**TOWN OF NEWBURGH  
PLANNING BOARD  
TECHNICAL REVIEW COMMENTS**

**PROJECT: SHOPPES AT UNION SQUARE AMENDED SITE PLAN**  
**PROJECT NO.: 2018-10**  
**PROJECT LOCATION: SECTION 96 – BLOCK 1 – LOT 6.2**  
**REVIEW DATE: 29 AUGUST, 2018**  
**MEETING DATE: 6 SEPTEMBER, 2018**  
**PROJECT REPRESENTATIVE: KARC PLANNING CONSULTANTS/LANGAN ENGINEERING**

Below, please find our responses to comments received from our previous submission to the Town of Newburgh Planning Board on July 19, 2018.

Drawn By: KEM  
 Checked By: TJD  
 Drawing No. **A101**

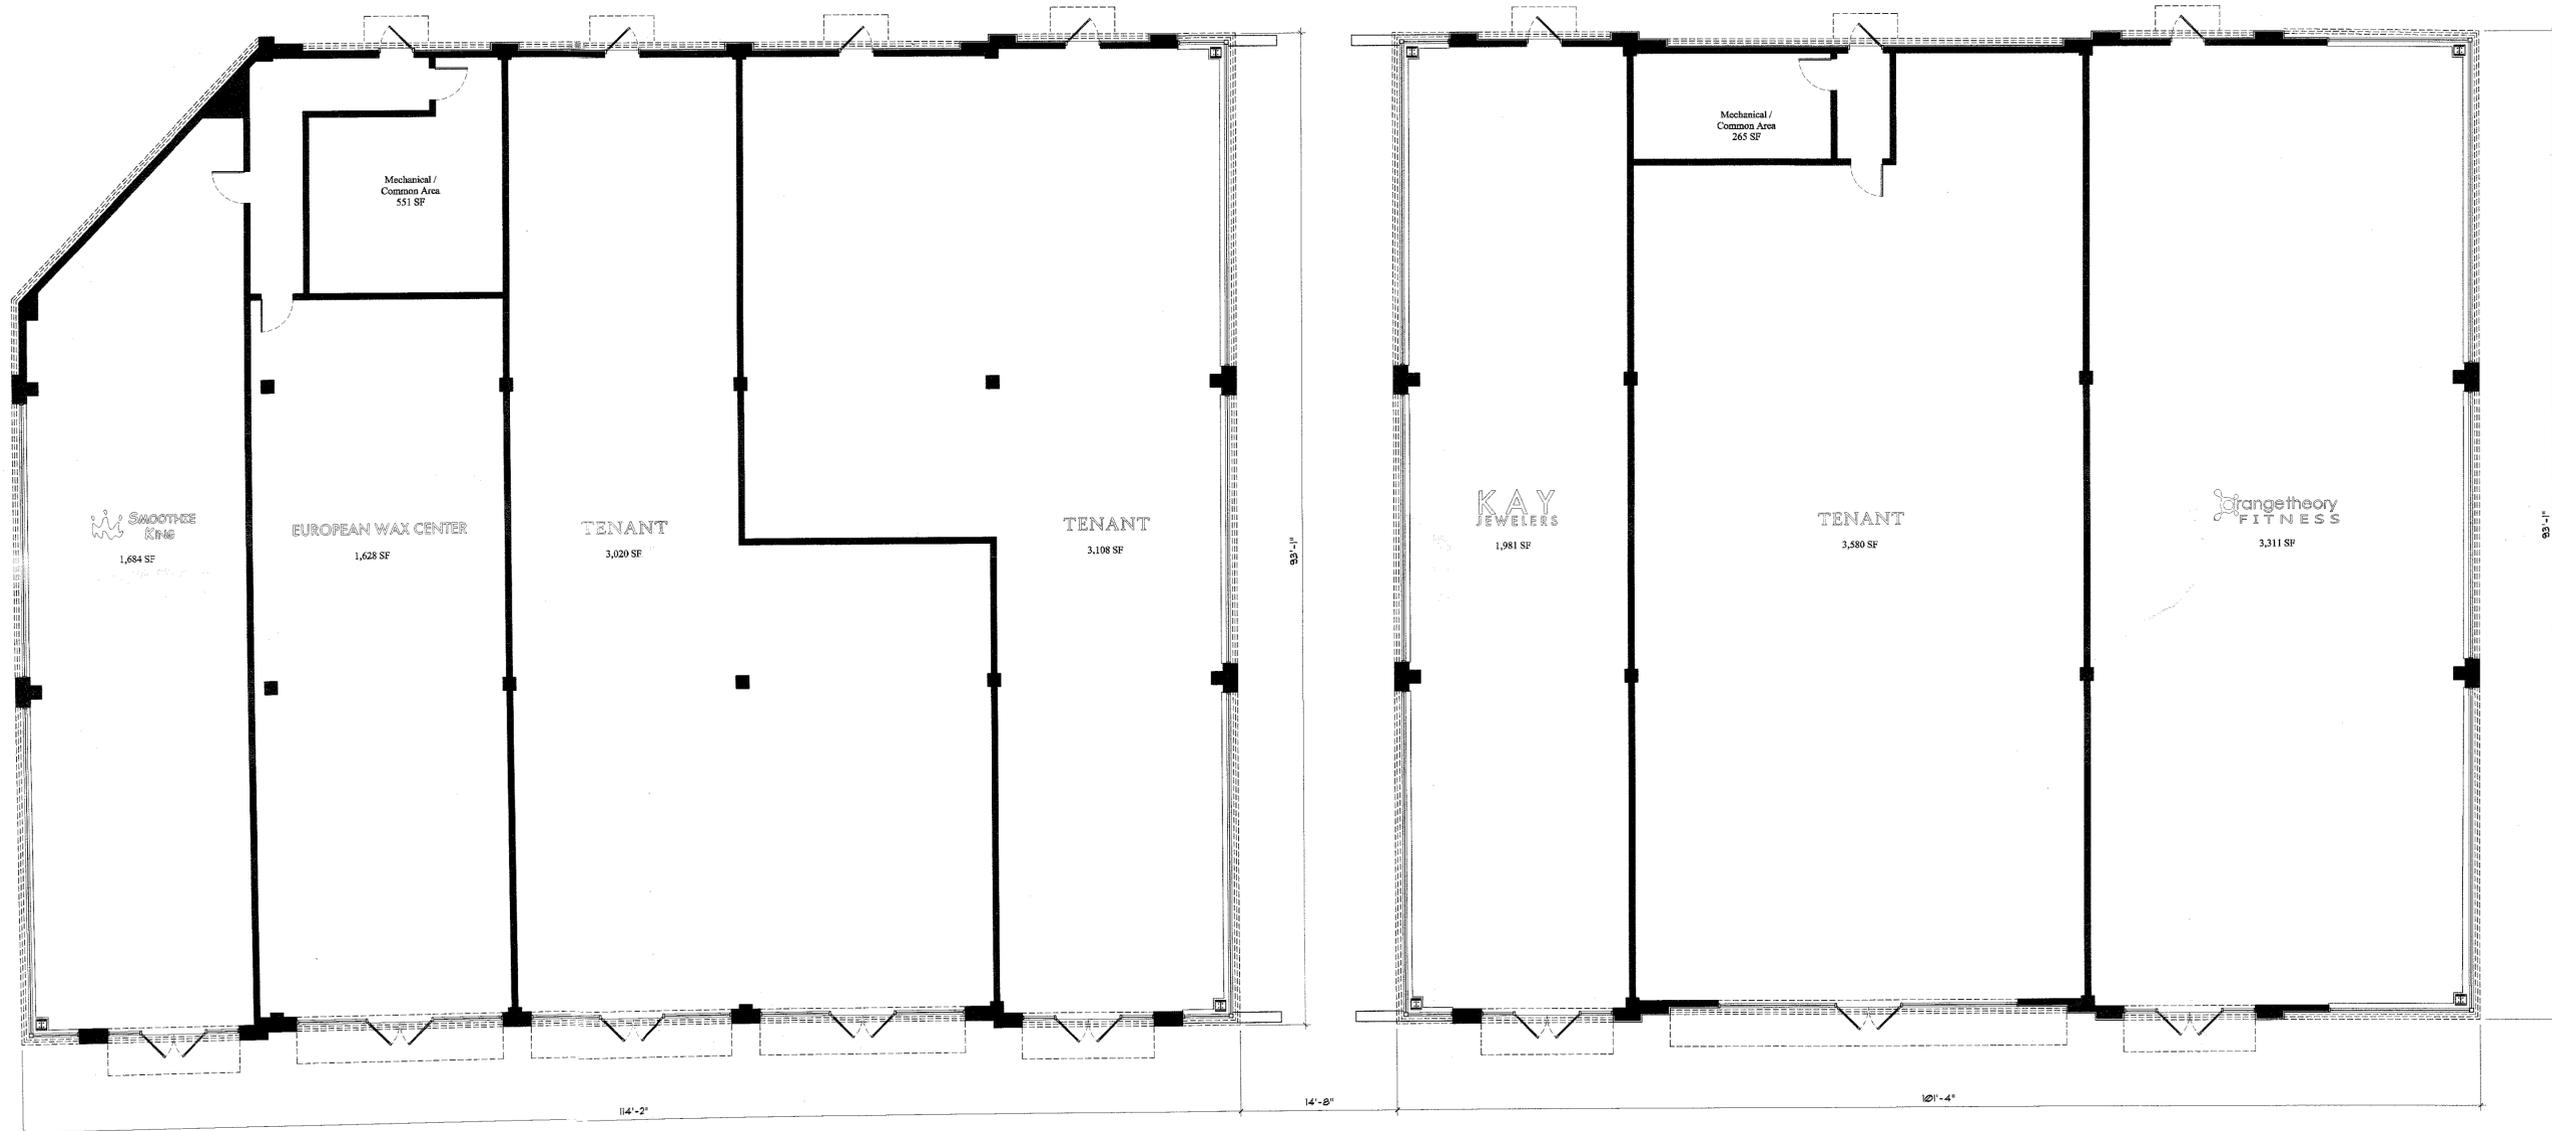
4. *The architectural plans (A101) do not indicate any protrusion from the building towards the drive-through lane, while the Front and Left elevations (A102) suggest there to be - the site plan shows none. In addition, the Left elevation doesn't show a drive-thru window as one would expect.*

Response: See attached amended Architectural drawings.

**SOIL EROSION AND SEDIMENT CONTROL DETAILS**

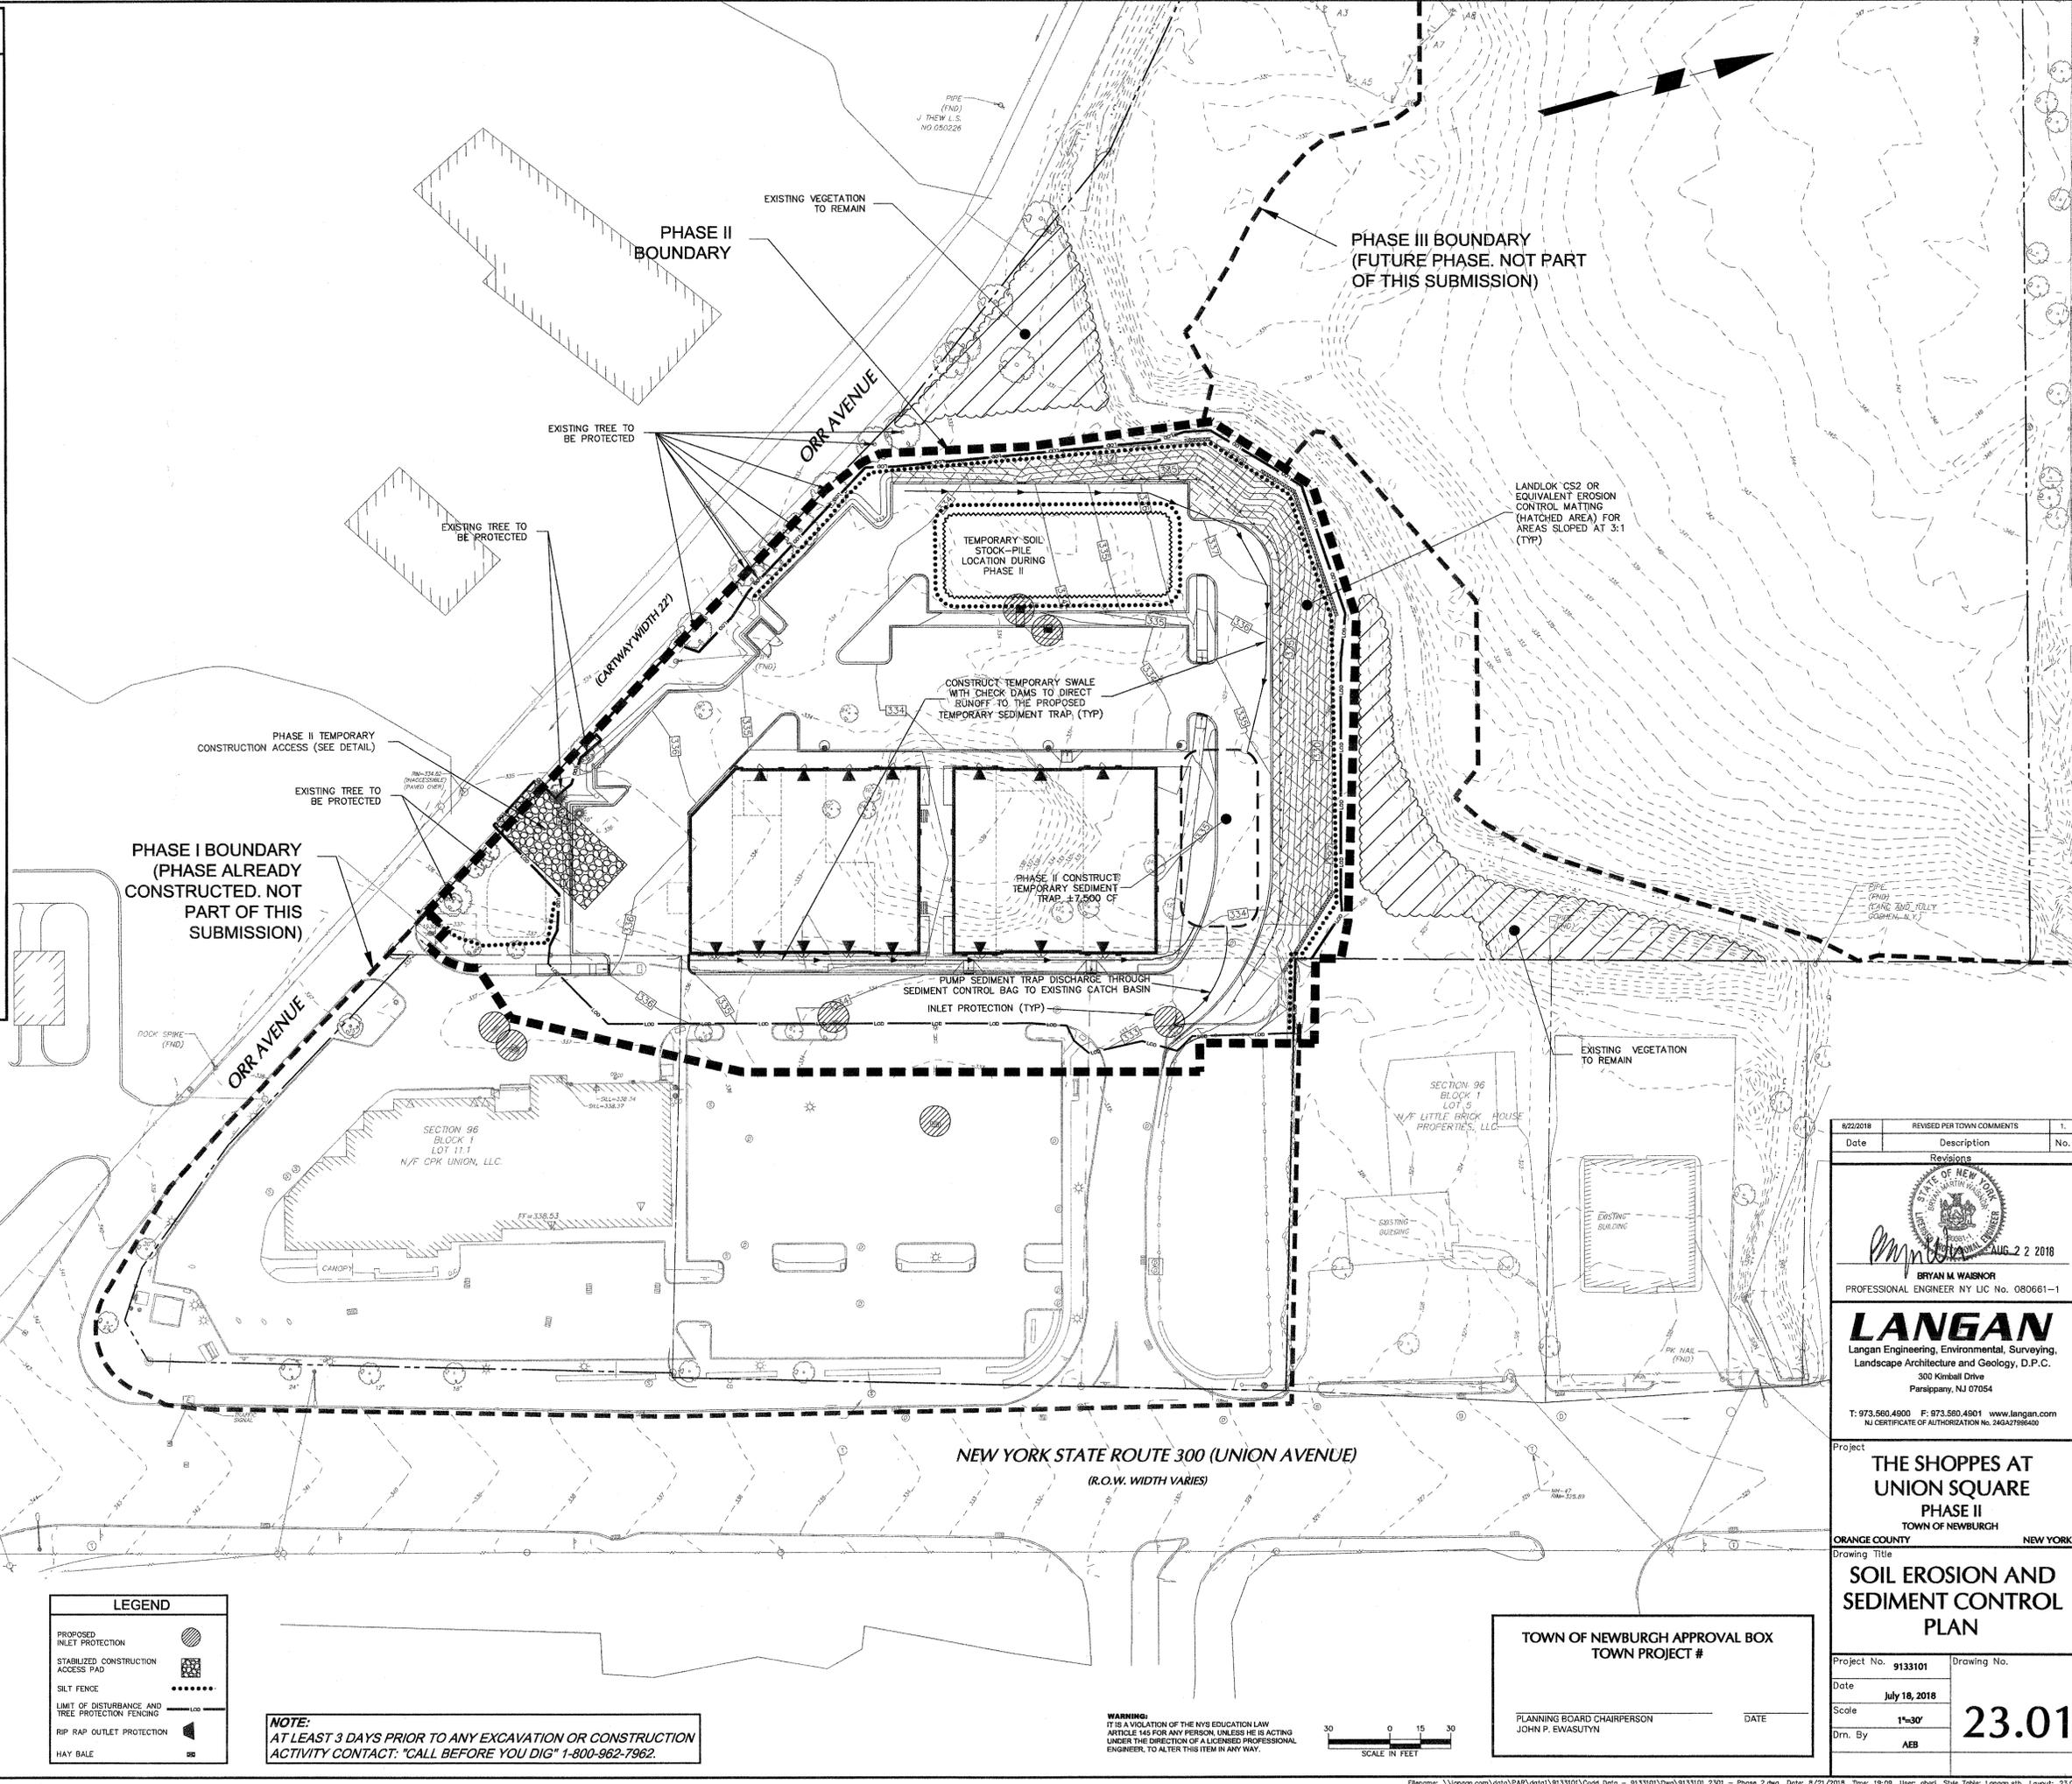
13. *Erosion sediment control plan should identify the discharge for the temporary sediment trap. Sediment trap may need to be phased as filling of the area is proposed.*

15. *A slope stabilization detail is provided. Areas for this to be used should be delineated on erosion control plans.*

Response: The soil erosion and sediment control plan has been revised to show the discharge for the temporary sediment trap.

Response: The soil erosion and sediment control plan has been revised to delineate the areas where the slope stabilization blanket shall be used.
